STAFF REPORT
WEST ALLIS PLAN COMMISSION
Wednesday, July 23rd, 2025
6:00 PM

2. Site, Landscaping, and Architectural Design Review for F Street 92, LLC, a proposed 5+ Unit Dwelling use, at 1405 S. 92nd St. (Tax Key No. 450-0502-000)

DATE: 7/17/2025
TO: City of West Allis
CC: Ryan Neidinger – RINKA
PROJECT: 92nd and Greenfield Multifamily
PROJECT NO.: 24101
RE: Responses to City Staff Plan Commission Comments

BUILDING C RENDERING PC-14

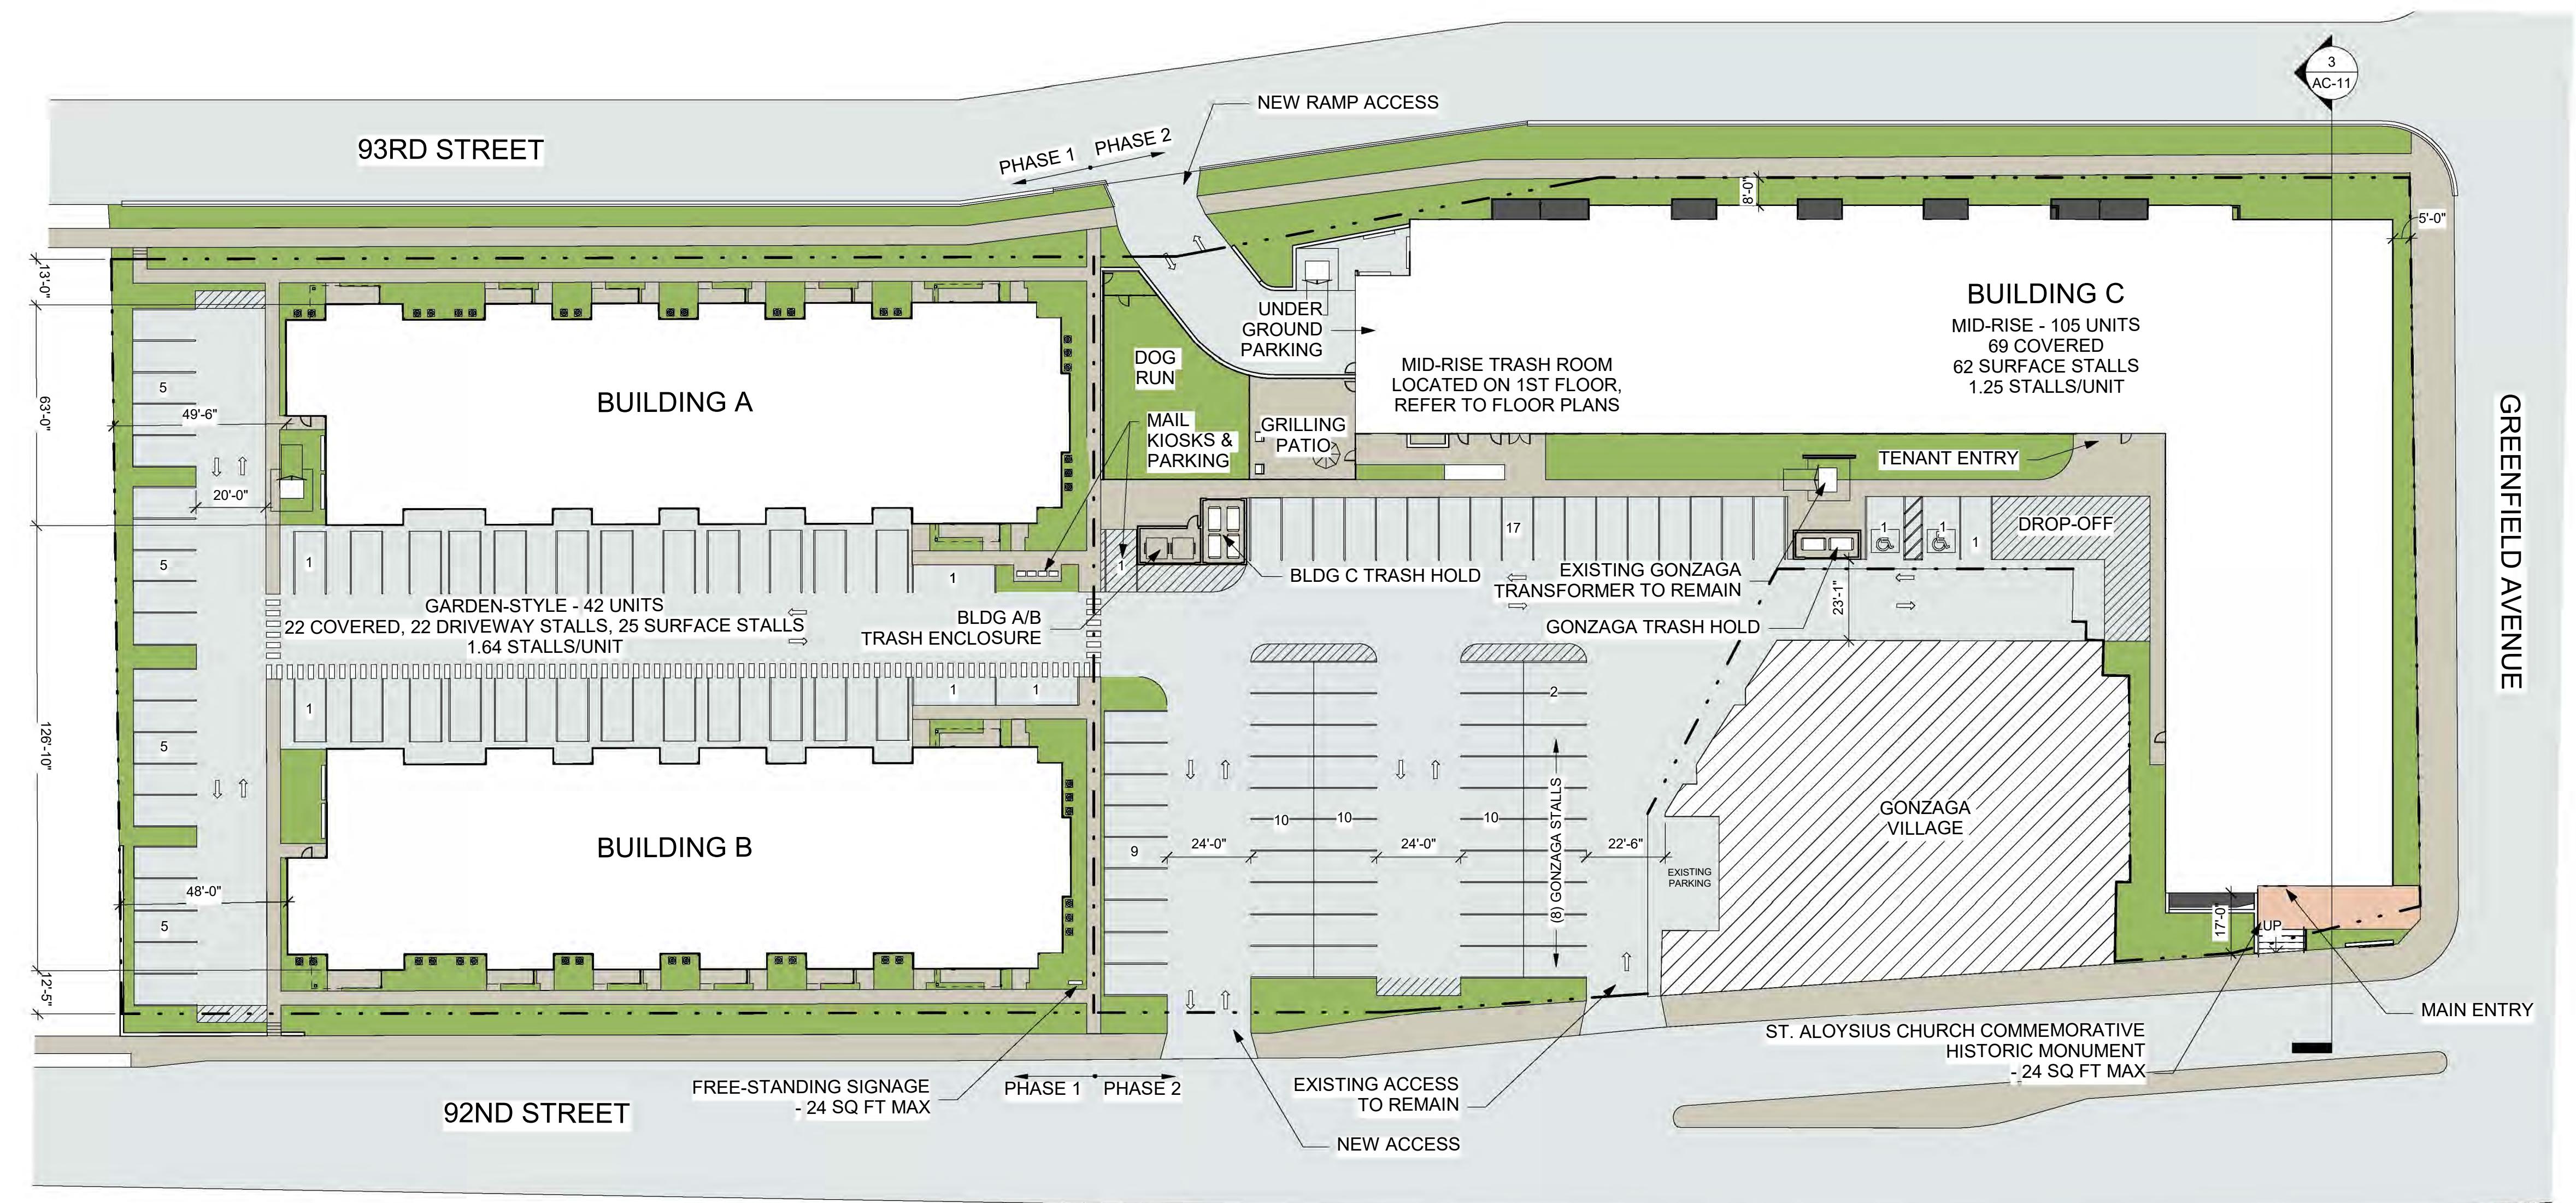
22. NE Corner and SE corner more windows or looking for a bit more presence primarily NE corner with that intersection.
RINKA Response: Refer to response #21. Also, NE corner will house a permanent historic memorial to St. Aloysius church and school.

BUILDING C ROOF PLAN PC-17

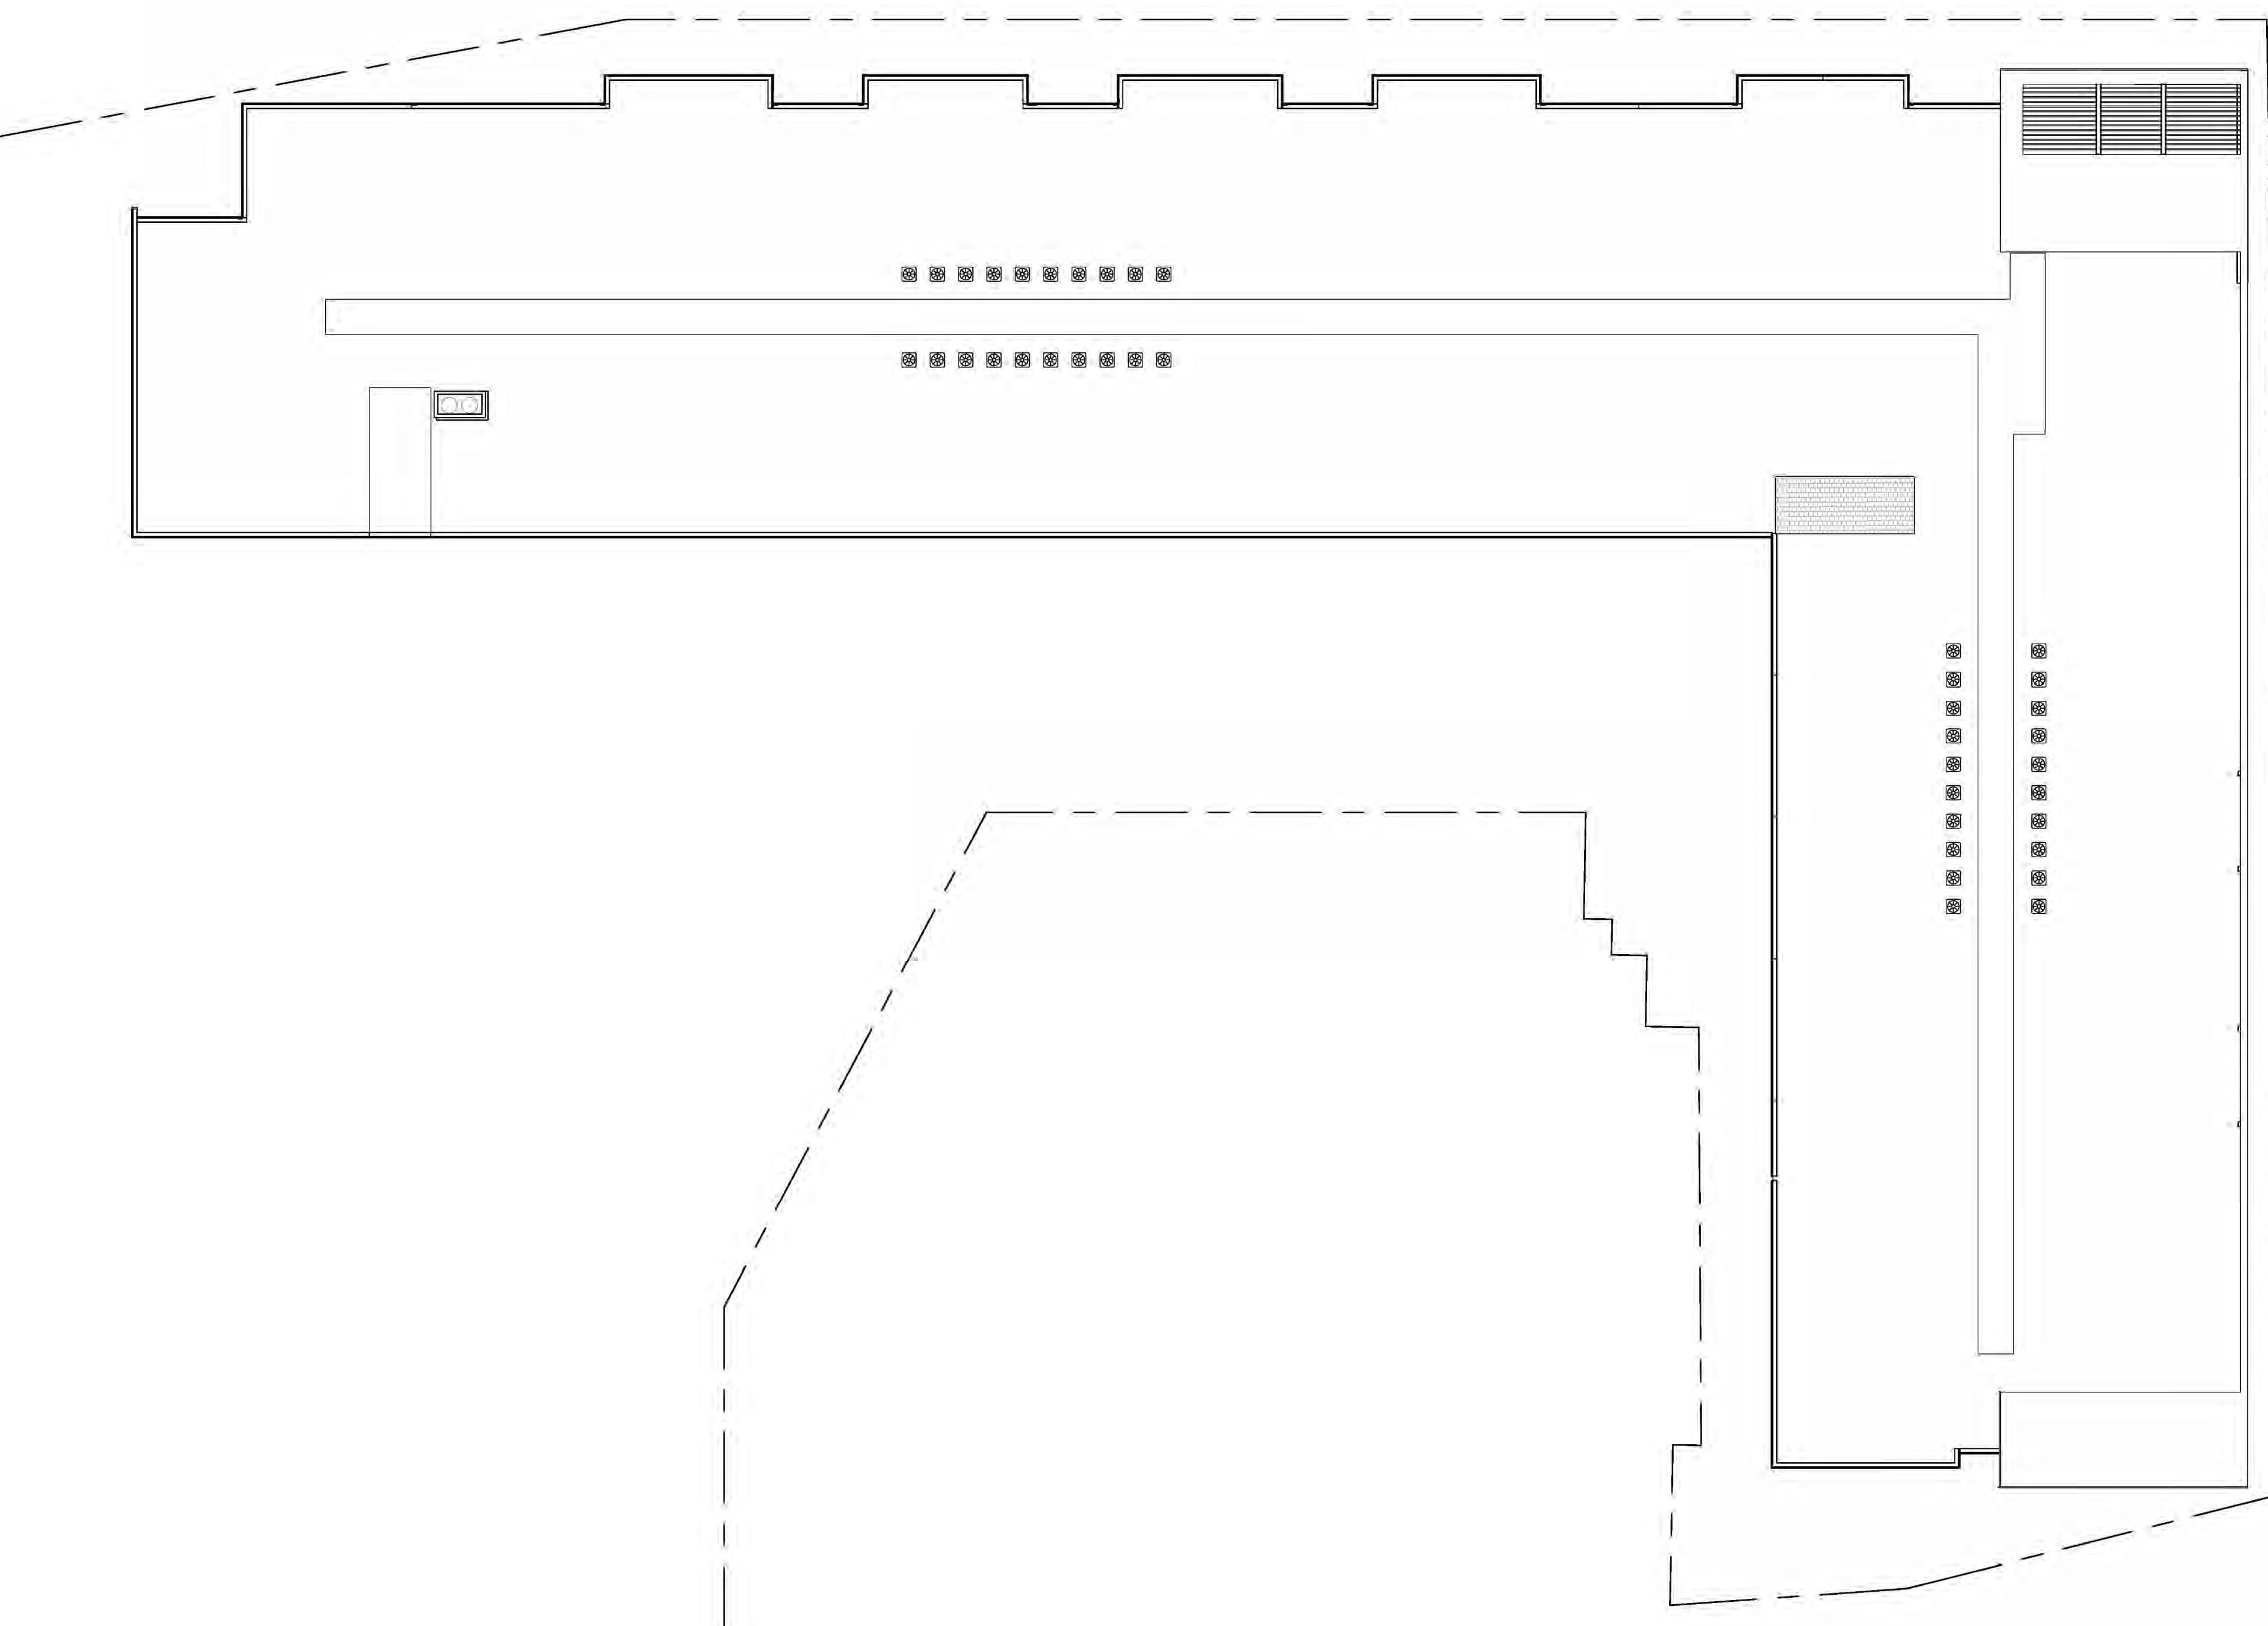
20. Submit a rooftop unit plan (RTU) to show location and determine if screening is necessary.

RINKA Response: Rinka to provide rooftop plan. MR building will have some units with internal mini-split systems. All other units will have rooftop AC units, of a standard residential size, located along central spine of building away from parapets and sight lines.
